General Conditions

Sarasota County Government staff has reviewed the above referenced plans, signed and sealed on August 7, 2024 and supplemental documentation. Pursuant to Chapter 124 of the Sarasota County Unified Development Code (UDC), construction is authorized subject to the following stipulations:

**Nokomis Office Suites**  
US 41 & Bayview Parkway  
Sarasota County, Florida

# SITE DEVELOPMENT PLAN NOKOMIS OFFICE PARK

SHEET #  
LA-1

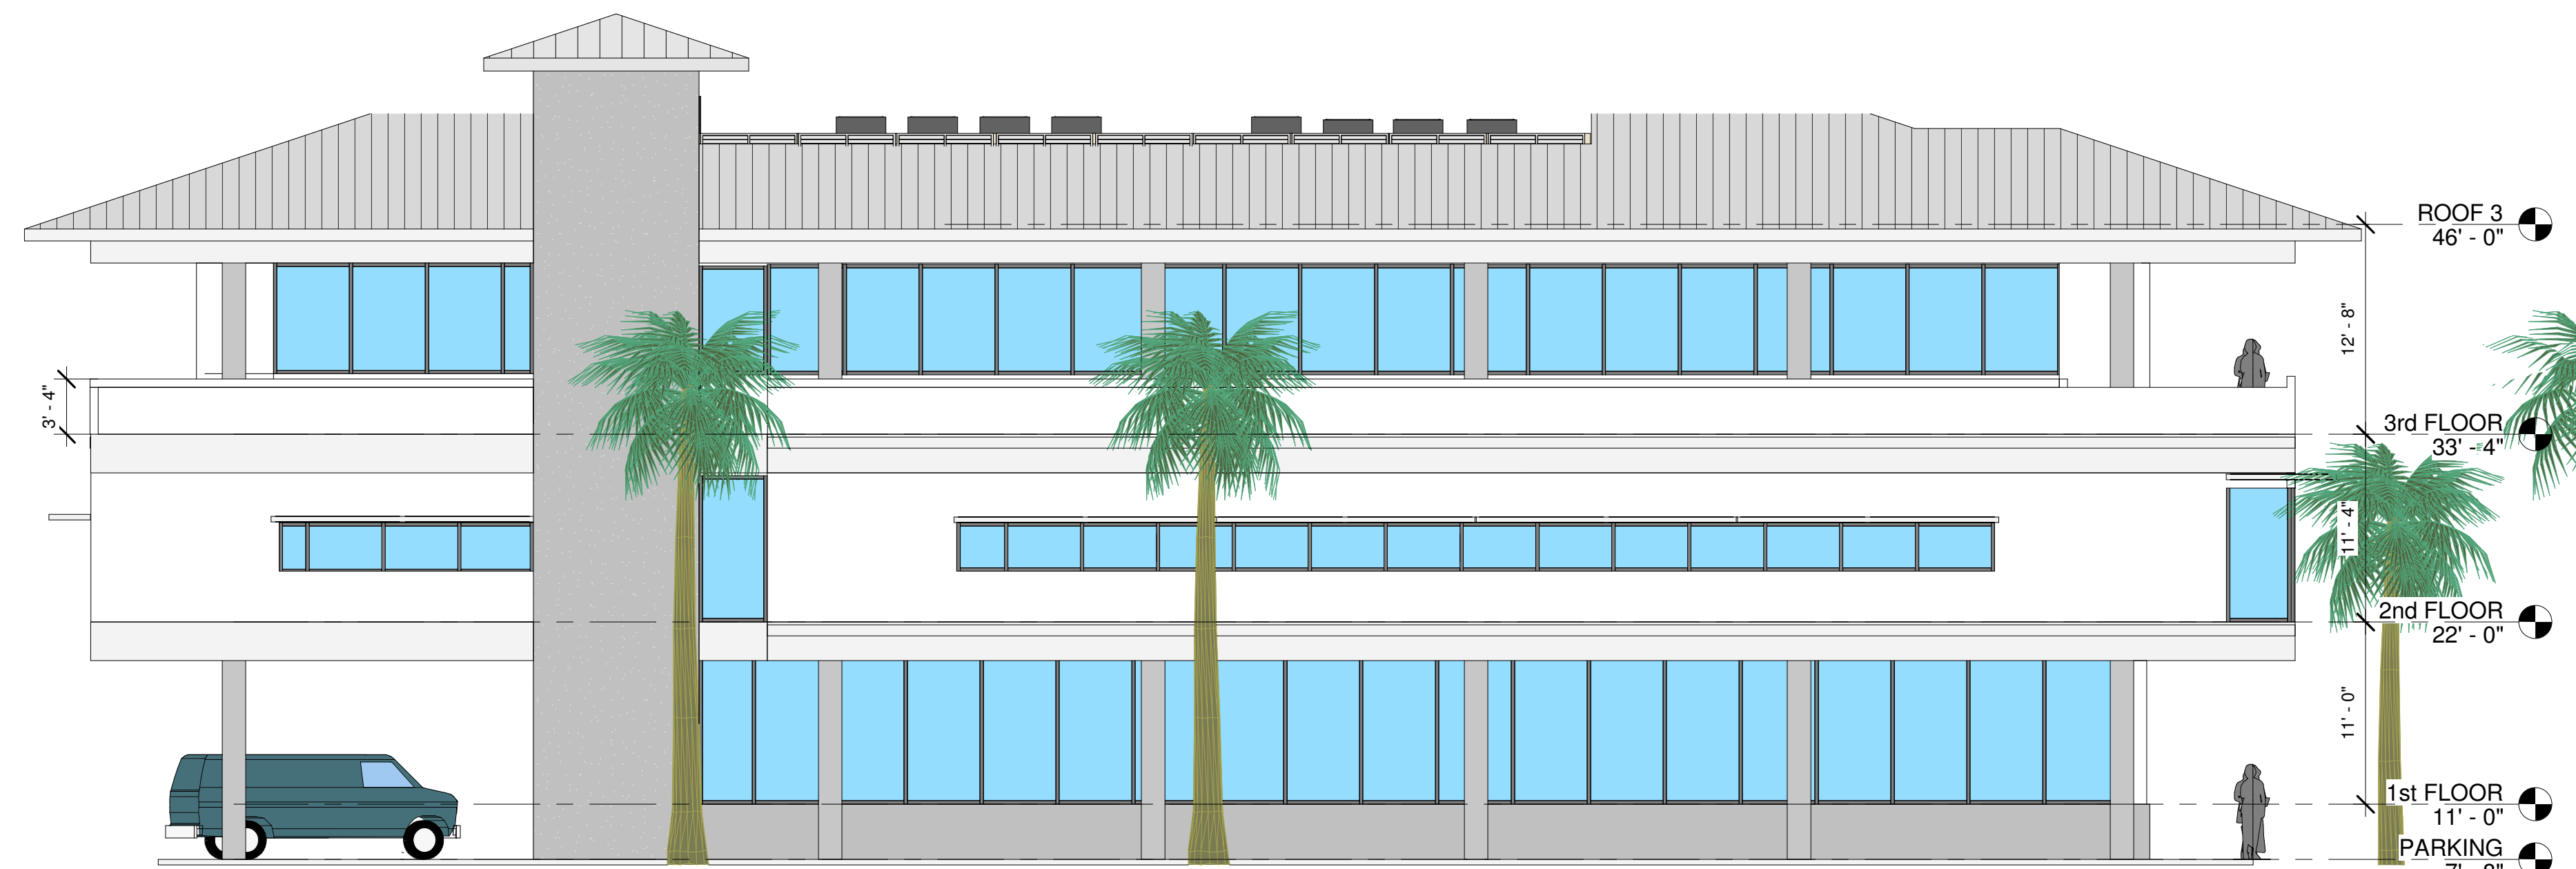
3 The approved project Landscape Plan shall be implemented. The Tree Survey (Figure LA-1. TR-1) includes at least 7 existing protected trees and 9 Sabal Palms to be relocated in accordance with the NOKOMIS CENTER REVITALIZATION PLAN (NO. 99-03-SP) Attachment A, Environmental Requirements. The tree planting schedule in the approved Landscape Plan (sheet LA-1) indicates 23 approved native trees planted within the project area. Tree replanting plan shall be implemented with replanting compliant with Best Management Practices ANSI 300 standards and site-specific tree protection plans

**UTILITY PLAN**  
**NOKOMIS OFFICE PARK**  
**498 SOUTH TAMAMI TRAIL**  
SECTION 1 TOWNSHIP 39 SOUTH, RANGE 18 EAST  
Sarasota County, Florida

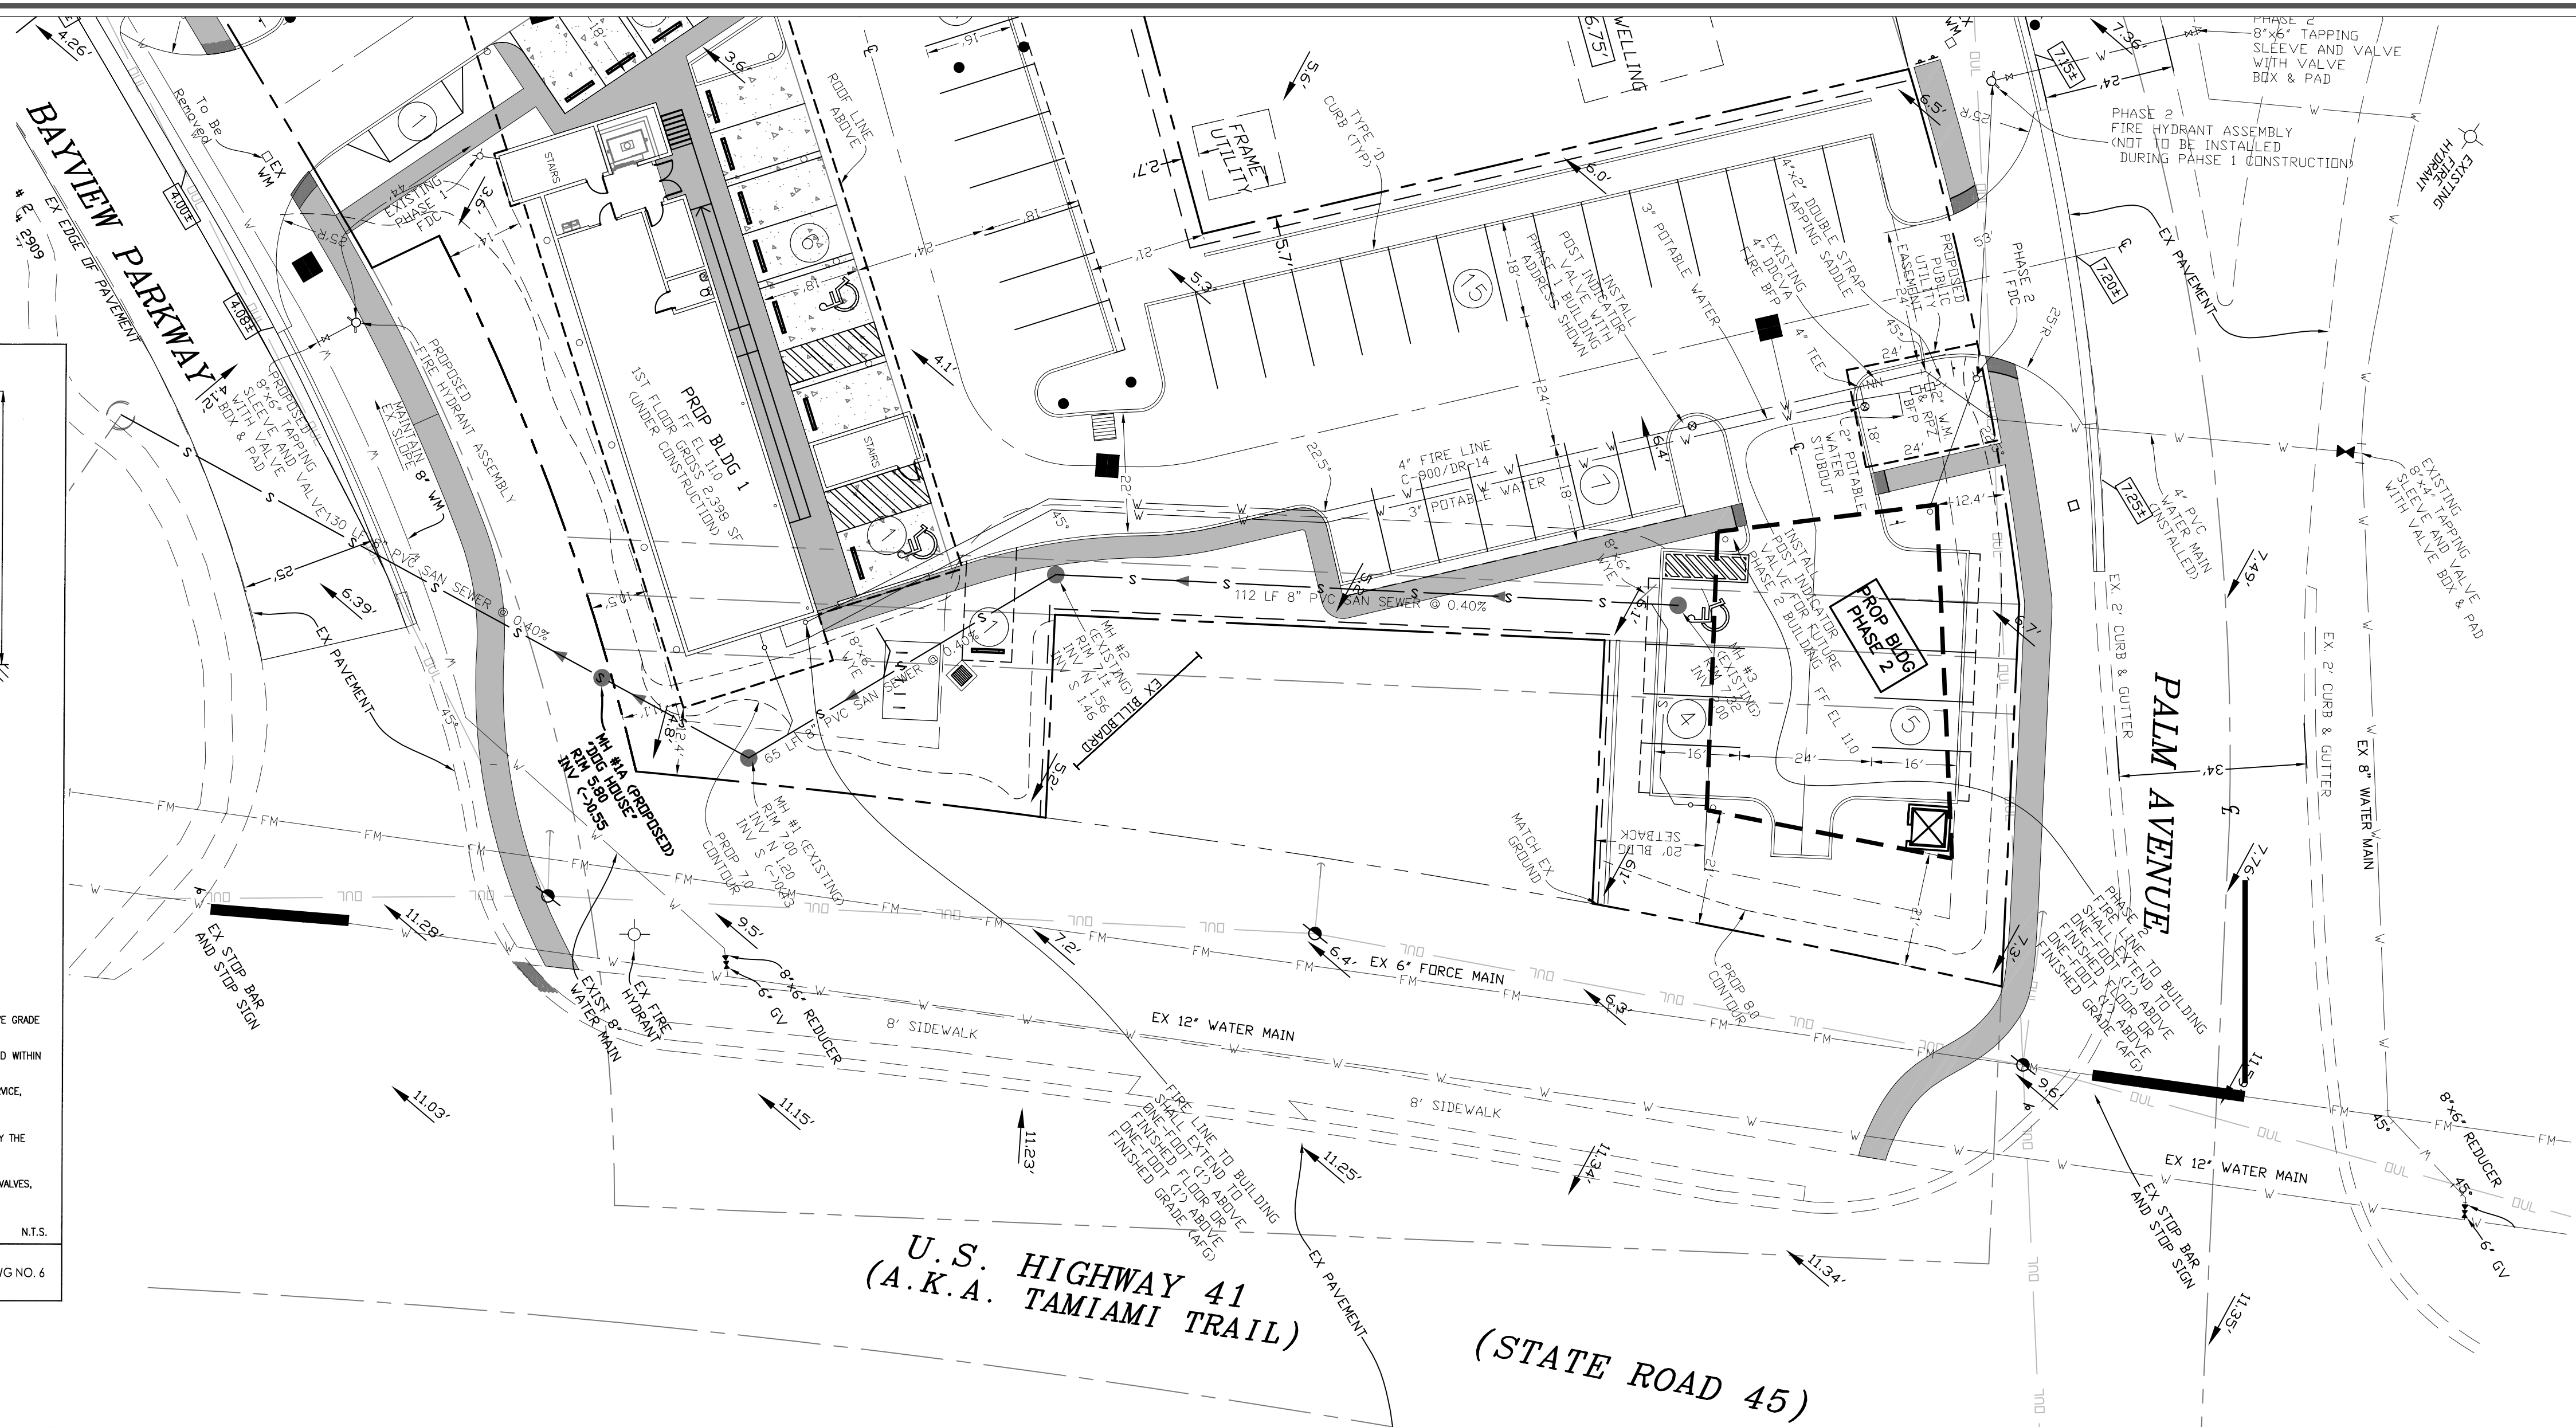
- Please relocate the Ph2 FDC that is currently shown in the proposed PUE outside of our easement.
